CITY PLANNING COMMISSION

- APPLICATION:**
- A. Tentative Map to divide 0.7+ vacant acres into three lots in the Flood (F) zone.
 - B. Special Permit to develop a six-unit, 6,048+ sq. ft. airspace condominium development.
 - C. Subdivision Modification to waive standard street improvements.

LOCATION: South side of Garden Highway at the terminus of Orchard Lane.

APPLC. NO. P87-359 **MEETING DATE** 9/24/87 **ITEM NO** 16

EXHIBIT A
WZ-100
SACRAMENTO, CALIFORNIA

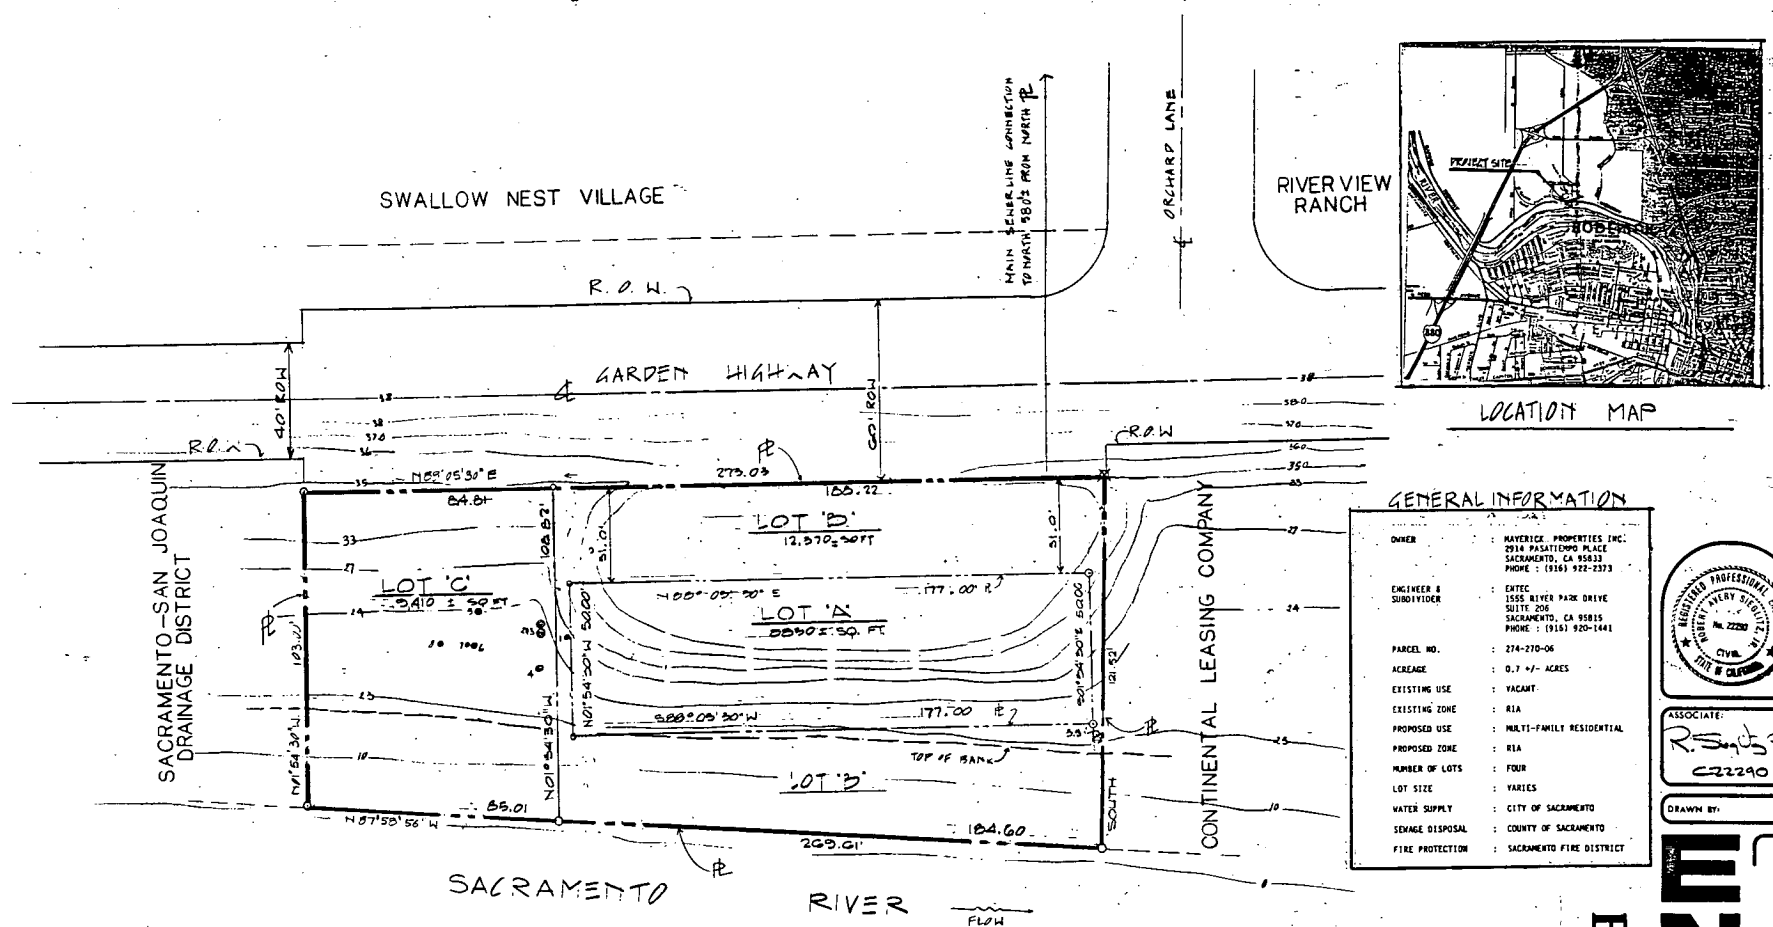
Residential developments are allowed in the Riverfront District and in the Flood zone with special permit approval. Planning staff finds the project to be an appropriate land use for the site if the tentative map is revised to show a one lot subdivision. Presently Lot C provides the only usable open space area for the project and provides the public view of the Sacramento River from the Garden Highway as required by the Riverfront District designation. The proposed density of the project is 8.5 dwelling units per acre when the acreage of the entire site (0.7+ acres) is used. This density is compatible with the densities of the two adjacent condominium developments, Riverbank Holding Company and Riverview Marina. If the Lot C acreage is removed from the calculations and allowed to develop separately the density of the condominium development would increase to 12 dwelling units per acre. Planning staff finds that six units on 0.5+ acres with little usable open space would be too intense of a project for the site. The applicant has indicated that he is willing to revise the map to indicate a one lot subdivision as recommended by Planning staff.

1. The map shall be revised to show a one lot subdivision;
2. Provide street lights pursuant to Section 40.811 of the City Code;
3. Prepare a sewer and drainage study for the review and approval of the City Engineer; may require off-site extensions and oversizing;

EXHIBIT B

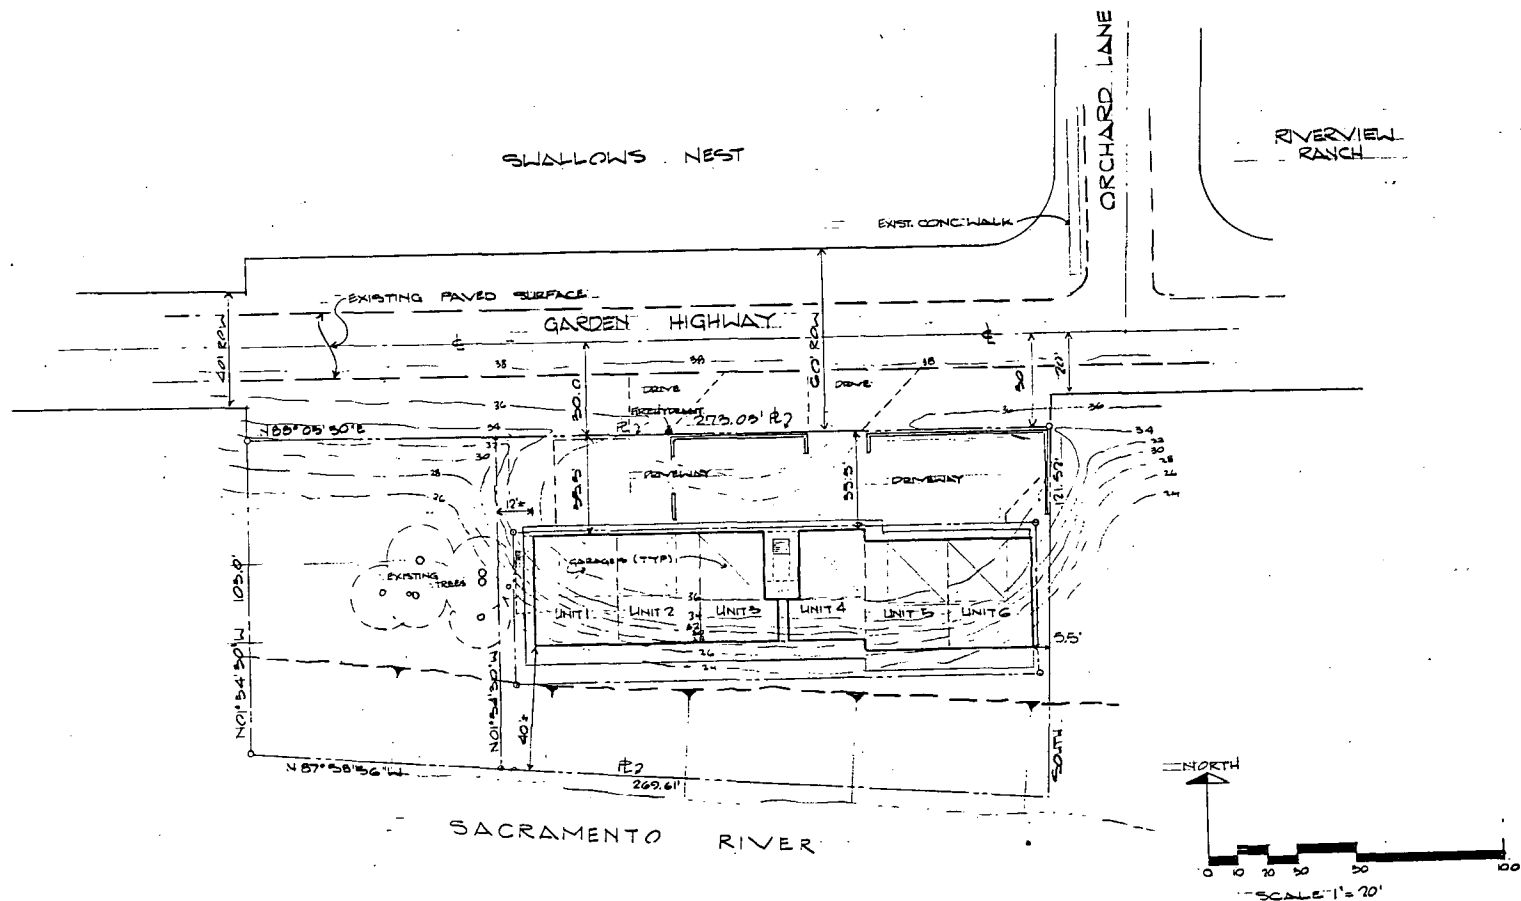
The applicant's site plan indicates the retention of the existing oak trees on the eastern portion of the site (Exhibit B). No other landscaping has been indicated. Planning staff recommends that a revised landscape and irrigation plan be submitted for Planning Director review and approval. The landscape plan should include: 1) the retention of all natural vegetation and inclusion of new vegetation as required by interested State and Federal Agencies; 2) a minimum four foot wide planter between the public right-of-way and any paved areas; and 3) a landscape plan for the western portion of the site which provides a usable open space area for the condominium residents.

Driveway entrances for the project as shown on the submitted site plan are inadequate. Two-way driveways must be a minimum of 24 feet wide. If driveways are proposed to be one-way only, the circulation plan must receive the approval of the City Traffic Engineer. The two proposed driveways for the project will need to be revised to the satisfaction of the Traffic Engineering Division prior to issuance of building permits.

A solid wall is indicated on the site plan adjacent to the public right-of-way. Any fencing in this area must meet the approval of the State Reclamation Board. Any fencing must also meet the visibility requirements of the Zoning Ordinance and Traffic Engineering Division. The Fire Department has indicated that they will not permit any obstacles in the driveway area adjacent to the condominium structures. The proposed fence in this area will need to be removed.

2. Development of the condominiums shall be supported by a post and beam construction with finished floor levels above the 100 year floodplain.
3. Revised landscape and irrigation plans shall be submitted for the review and approval of the Planning Director prior to issuance of building permits. The landscape plans shall indicate the following:

- b. retention of the existing Oak Grove;
 - c. a minimum four foot wide planter between the public right-of-way and any paved areas; and
 - d. a landscape plan for the western portion of the site which provides a usable open space area for condominium residents.

4. Construction work and placement of impervious surfaces shall be approved by the City Arborist.
5. The applicant shall submit the detailed plans which indicate the driveway locations for the review and approval of the City Traffic Engineer prior to issuance of building permits.

6. The design and materials of the fence proposed adjacent to the Garden Highway right-of-way shall be subject to the review and approval of the Planning Director prior to issuance of building permits. The proposed fence shall also meet the requirements of the State Reclamation Board, City Fire Department, and the visibility requirements of the Zoning Ordinance and Traffic Engineering Division.

EXHIBIT C

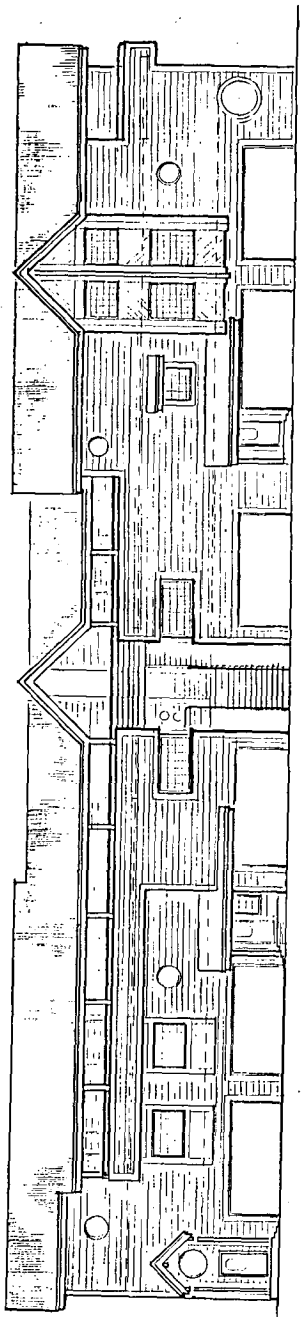
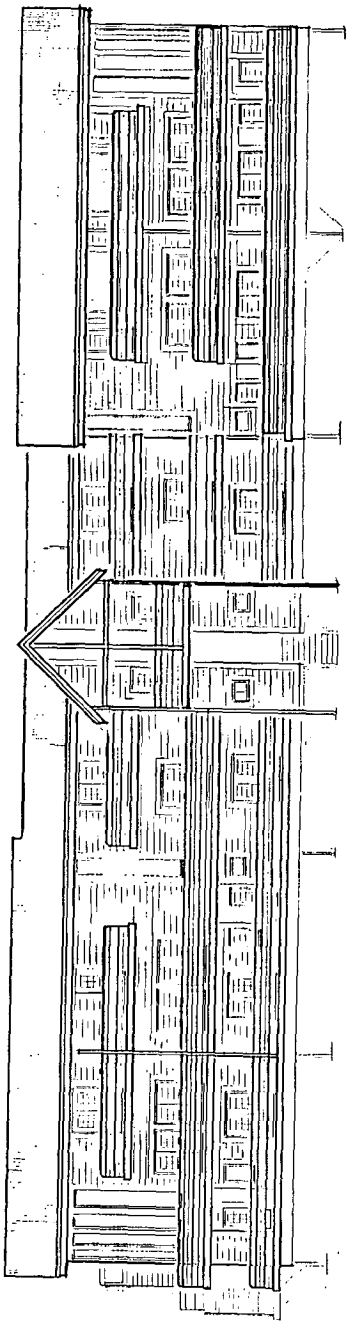
The applicant has met with Planning staff several times to discuss the proposed building elevations. The proposed units are three (Exhibits C-E) stories, 29 feet high measured from the Garden Highway side of the structure to the top of the plate line. Two of the units have three bedrooms, the remaining four units have two bedrooms. Each level of each unit has an outdoor balcony facing the river. Each unit also has a two car garage. Proposed building materials are wood shiplap siding and a metal roof. In order to avoid one long building facade, the applicant has off-set units 5 and 6 from the rest of the four units and provided different roof pitches.

Planning staff finds that the applicant has made substantial progress in designing a residential project that is compatible with the theme of the Riverfront District. Some more detailing, however, is needed on the elevations. Staff recommends that revised plans and elevations be submitted for the review of the City Design Review staff prior to issuance of building permits.

7. Revised elevations for the project shall be submitted for the review and approval of City Design Review staff prior to issuance of building permits.
